ACCESS AUDIT REPORT

Accessible University of Delhi

November 2007

Address - Kirori Mal College, University of Delhi, Maurice Nagar, Delhi – 110007

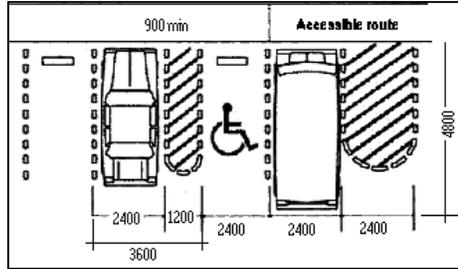
The exit gate from the parking is narrow and has a big step.

- ✚ **Clear wide opening of 900mm to be provided with leveled (no-step) flooring.**

ENTRANCE TO THE MAIN BUILDING

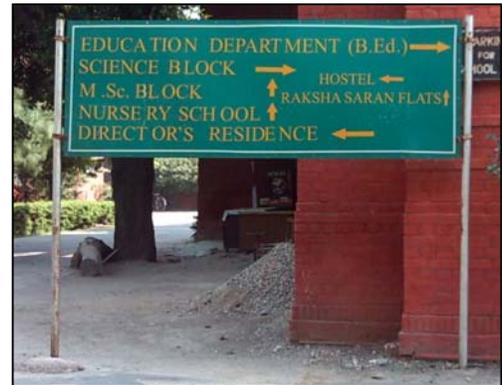
There are two entrances for the teaching blocks.

- ✚ Way finding signages to be provided which benefits everyone (refer photo on right).

MAIN ENTRANCE TO THE ADMINISTRATIVE BLOCK

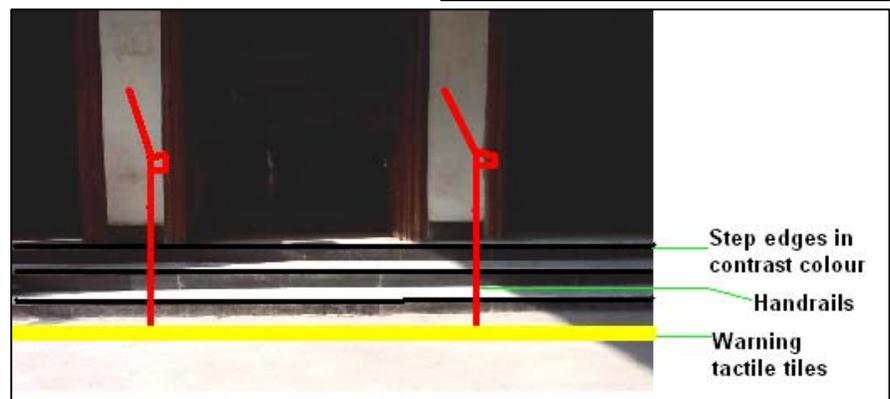
Three steps mark the entrance (total height- 570mm).

- ✚ L- shape ramp with handrails (as per Annexure I and III) is proposed.
- ✚ For the steps- handrails, warning tactile tiles and contrast colour on the step edges are proposed.

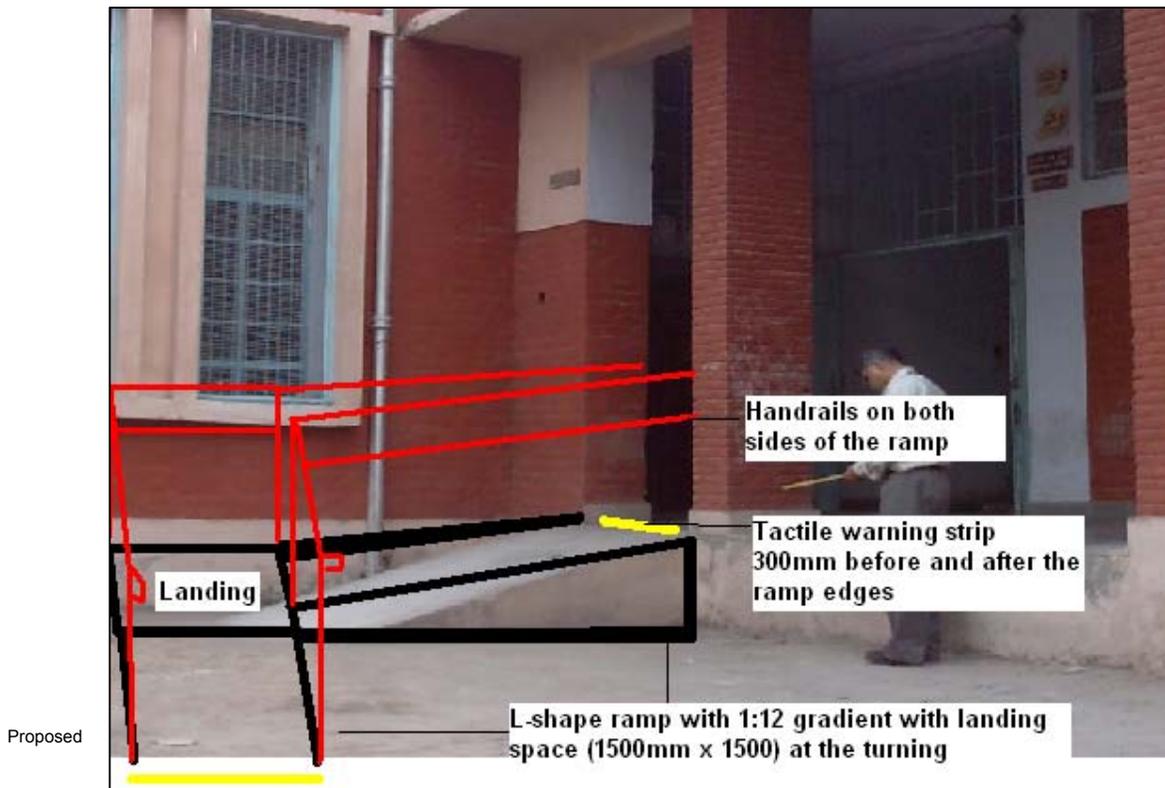
Steep ramp without handrails mark the entrance to the teaching block.

- ✚ L-shape ramp with landing (refer proposed illustration and Annexure I & II) should be provided.
- ✚ Handrails (refer Annexure III)
- ✚ Warning strip (Annexure IV) should be provided 300mm before and after the steps and ramp edges.

WAY FINDING SIGNAGES

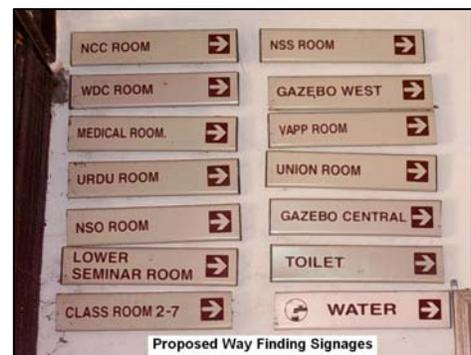
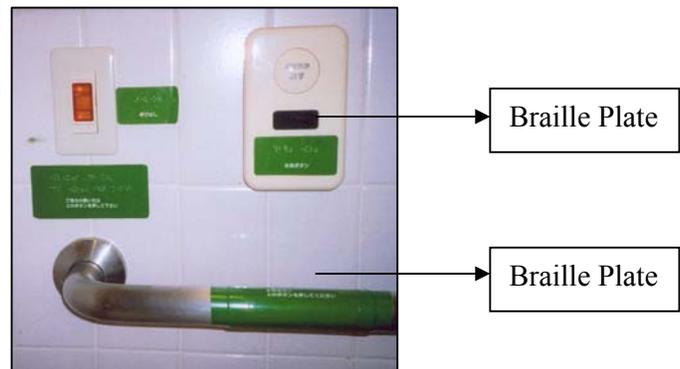
Signage on the wall is provided at strategic locations regarding all the amenities/ lecture room etc.

- ✚ However, floor wise key plans are proposed next to steps on each floor and at the proposed ramp.
- ✚ Floor signage may be provided that help identify facilities by persons with short stature, wheelchair users etc.
- ✚ Braille plates giving information of class rooms/labs etc. may be provided on the handrails of ramp and stairs.

GENERAL CIRCULATION AREA

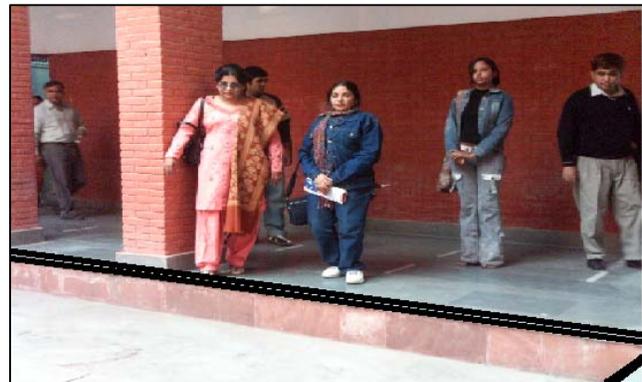
Placement of the signage for the 'Office' is nicely done. However the font is too small and is not clearly visible.

- ✚ Signage to be as per the standards mentioned on page 5.

STEPS & STAIRS

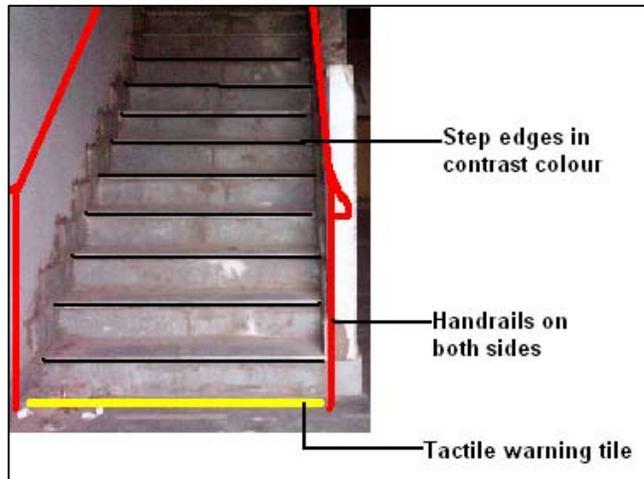
Handrail height is at 1050mm.

There is no extension of handrails for first step and wall side handrails are missing.

- ✚ Step riser is 170mm, to be reduced to 150mm in all new constructions.
- ✚ Handrails to be provided on wall side (at 900mm) to help persons with reduced mobility to take support while descending (refer Annexure II).
- ✚ **Stair edges** (50mm min.) should have bright contrasting colors, which helps persons with low vision to identify height and depth of each step. Refer Annexure II for steps and Annexure III for handrail standards.

Approach

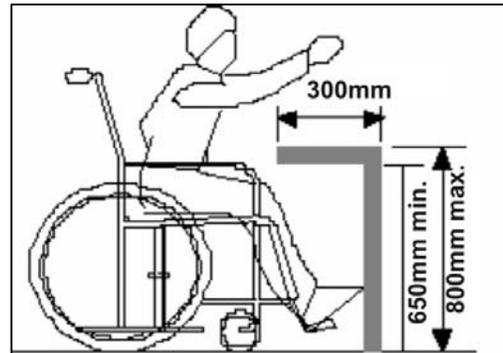
A steep ramp (newly constructed) marks the Science block.

- ✚ It is proposed to relocate the ramp in the centre of the corridor for better gradient and easy access from the main entrance passage.
- ✚ L-shape ramp with handrails as per Annexure I & III to be provided.

LIBRARY

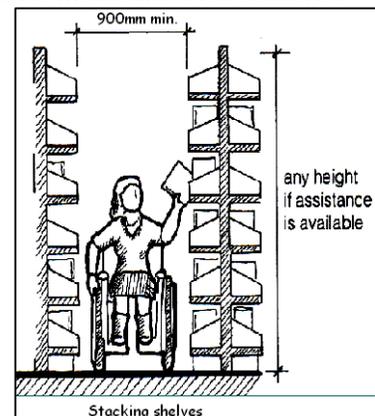
Temporary wooden ramp (gradient 1:2) has been provided at the entrance step of 280mm height.

Two iron grating covers have been placed as foot mats. These can trap front wheels of a wheelchair as well as white cane and the collapsible gate's threshold poses a trip hazard for everybody.

- It is proposed to provide a permanent concrete ramp as per annexure I.

- Coir mat and grating covers to be completely removed as it hampers free movement to be removed and rubber foot mats may be placed in a niche in the floor surface.

Staircase to the reading rooms in the Library

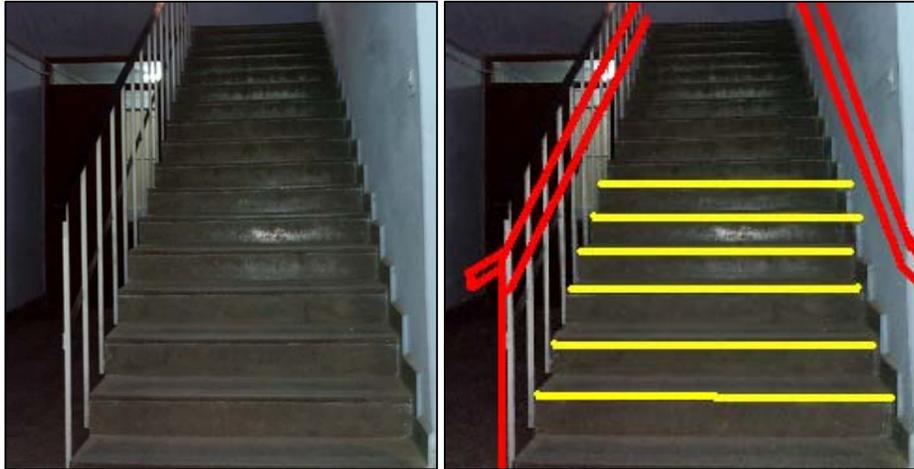
Aisle space between stacks is only 680mm.

- Reading table bottom clearance is 650mm, to be at least 700mm
- Uniform illumination on the reading tables should be provided.
- Books in Braille and Screen Reading Software to be provided for persons with vision impairment. A separate room with bigger space to be allocated for Braille Library.
- Aisle space (900mm min.) between stacking shelves/almirah to be maintained for students using mobility aids.

CANTEEN

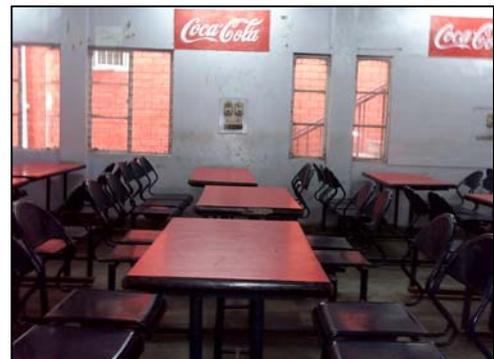
Way to canteen is extremely dirty and loose sand prohibits free movement of wheelchair/walker/walking stick etc.

✚ **Pathway to be paved with leveled and non skid surface.**

✚ Entrance to the canteen to have L-shape ramp along side the wall as per Annexure I.
